The Commission has issued the enclosed Amendment Nos. 26 and 11 to Facility Operating License Nos. DPR-53 and DPR-69 for the Calvert Cliffs Nuclear Power Plant Unit Nos. 1 and 2, respectively. The amendments are in response to your August 5, 1977 application relating to interim Standard Technical Specifications (STS) on Fire Protection.

AMENDMENT TO FACILITY OPERATING LICENSE

Amendment No. 26  
License No. DPR-53

ATTACHMENT TO LICENSE AMENDMENT NO. 26

FIGURE 6.2-1  
Management Organization Chart  
Calvert Cliffs Nuclear Power Plant  
Baltimore Gas & Electric Company

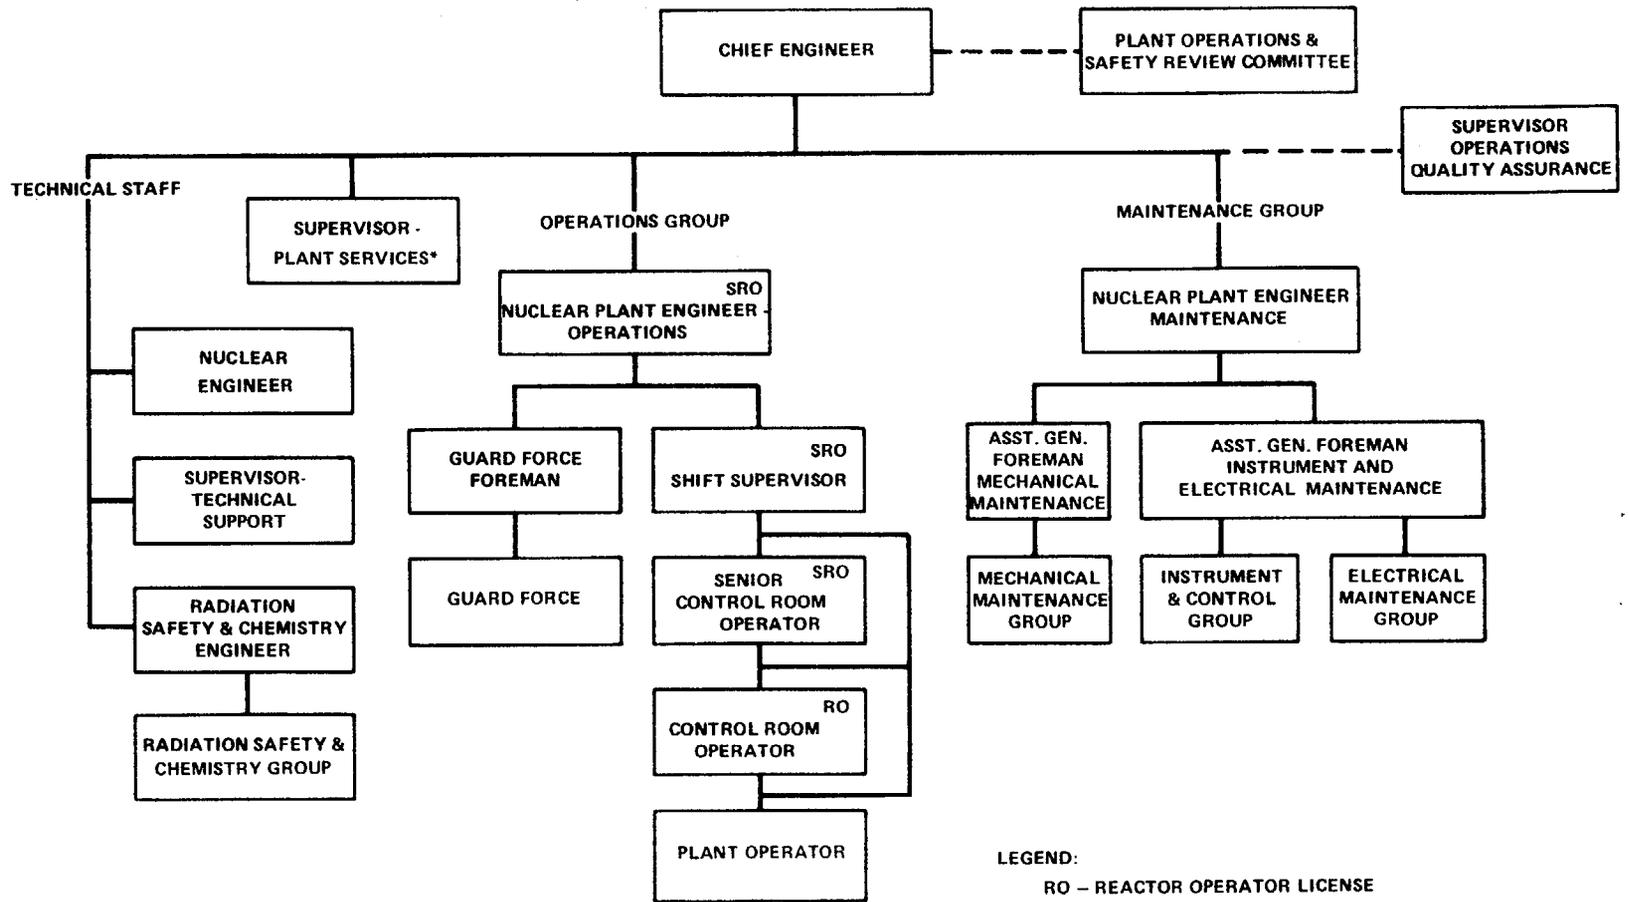
6.2.1 The offsite organization for facility management and technical support shall be as shown on Figure 6.2-1.

\*CORPORATE RESPONSIBILITY FOR FIRE PROTECTION PROGRAM

Management Organization Chart  
Calvert Cliffs Nuclear Power Plant  
Baltimore Gas & Electric Company

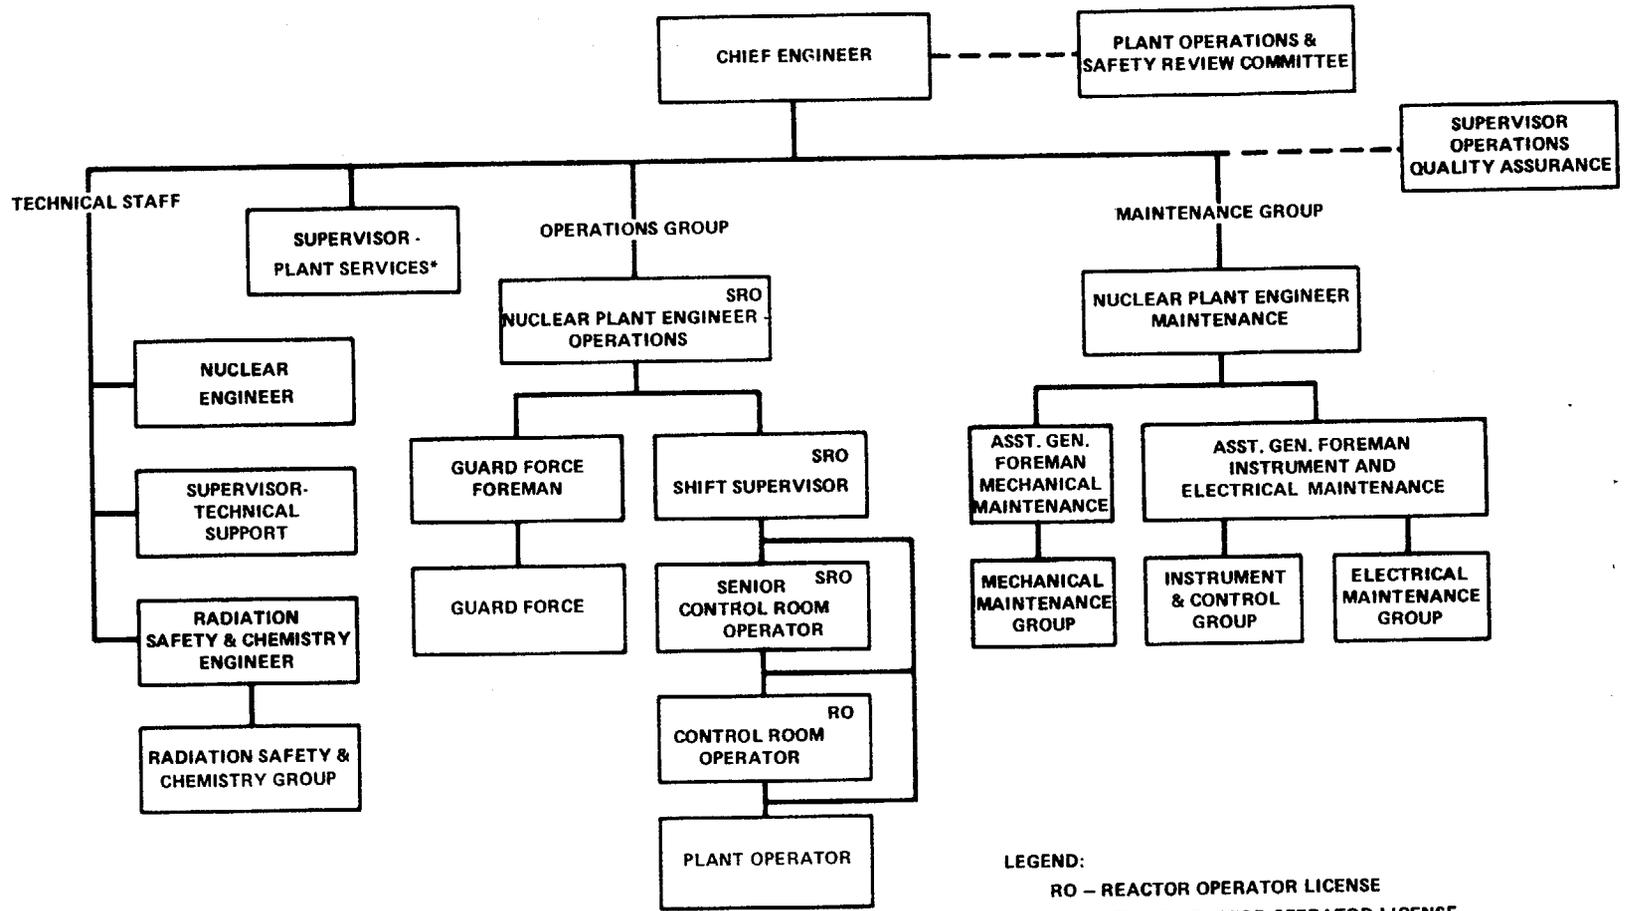
6.2.1 The offsite organization for facility management and technical support shall be as shown on Figure 6.2-1.
